Service Bulletin

Bulletin No. 2014-68 OEM No. 2014-66
Circulate to:	Sales Manager	Accounting	Service Manager	Technician	Parts Manager

Official Recall Notification United States Federal Boat Safety Act —Mercury Diesel 3.0L Tier III Turbocharger Oil Supply Line Update

Green dot showing that rework has been performed

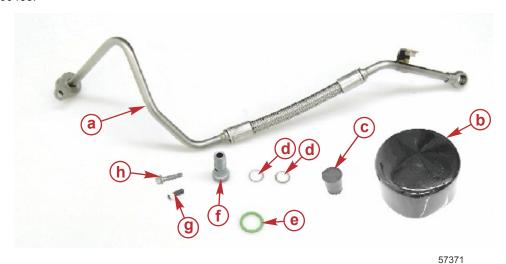
Engines reworked by the factory or by an authorized dealer will have a mark indicating that the rework has been performed. With the engine removed from the shipping container, or installed in a boat the rework identification will be a green dot placed to the left of the serial number decal.

- 24. Reconnect the battery. Refer to your service guide for the proper procedure.
- 25. Test run to check for engine oil leaks.
- 26. Mark the engine with a green paint dot to indicate that the new oil line has been installed.
- 27. Reinstall the engine cover.

Banjo bolt being removed

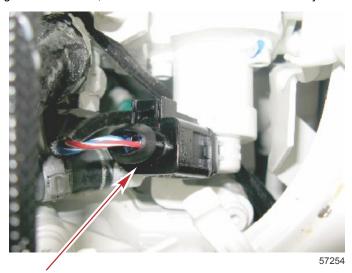
4. Remove the banjo bolt securing the oil supply line to the turbocharger.

Spread the fuel lines apart to gain access to the oil supply line

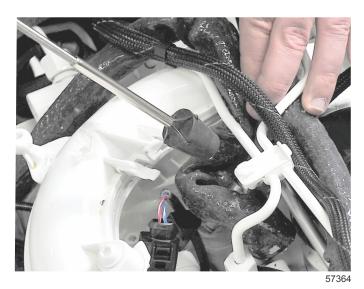
9. Remove the fuel line and return fuel line from the fuel line retainer, and spread the lines apart.

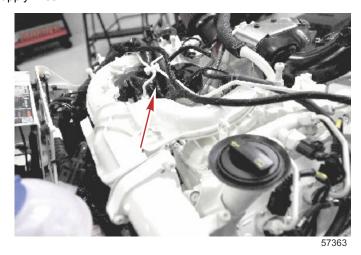
b. As you are picking the line straight up, begin to rotate the line at the top of the oil supply line towards the middle of the engine.

c. This rotation and lifting will place the flange of the oil supply line even with the top of the oil filter canister and the main fuel supply line. Some manipulation of the fuel supply line may be needed during this step.

O-ring installed on oil line

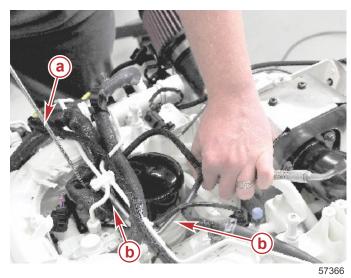
12. Assemble the new oil supply O-ring onto the new oil supply line. Do not apply oil to the O-ring. Doing so may introduce contaminants.
